System Impact Assessment Report

Project: *Woodstock Area Transmission Reinforcement*

CAA ID 2006-253

April 24, 2007

Figure 2. Proposed Arrangement of Karn TS

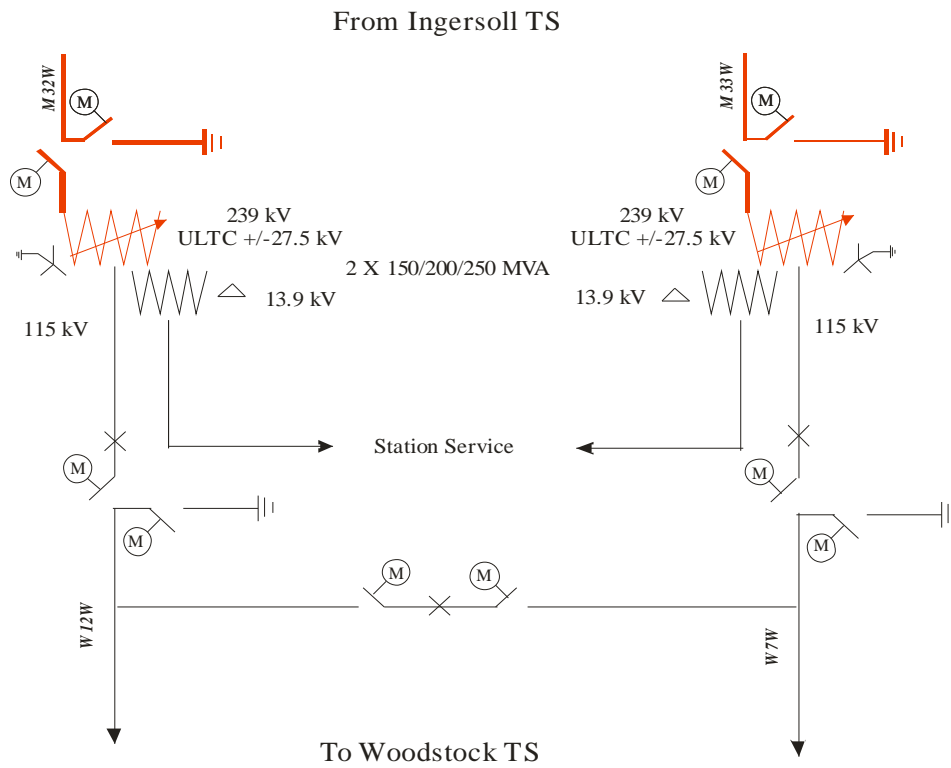
Hydro One proposes to connect each autotransformer to the IESO-controlled grid via one 230 kV motorized disconnect switch with a maximum operating voltage of 250 kV.

It is thus required that Hydro One install two 230 kV circuit switchers on the high voltage side of the autotransformers to allow quick restoration of the 230 kV circuit in case of an autotransformer fault.

The diagram that was provided by the applicant shows each transformer being separated from the transmission system via a motorized disconnection switch. As detailed in section 2.1.3, the IESO requires that the disconnect switches be replaced with circuit switchers. For this particular arrangement the Transmission System Code requires that transfer trip of the Transmitter's breakers at the terminal stations be provided for transformer faults or for a condition of failure to operate of the 115 kV breakers. In the case of Karn TS, which is to be connected to the double circuit 230 kV lines M32W/M33W the transfer trip must be sent to the Buchanan TS and Middleport TS terminals of the faulted circuit.

The circuit switchers will allow the fast disconnection of the faulted elements and the restoration of the affected 230 kV circuit. In addition, the isolation of one of the new autotransformers for planned outages can be achieved by operating the circuit switcher without removing from service the 230 kV circuit.
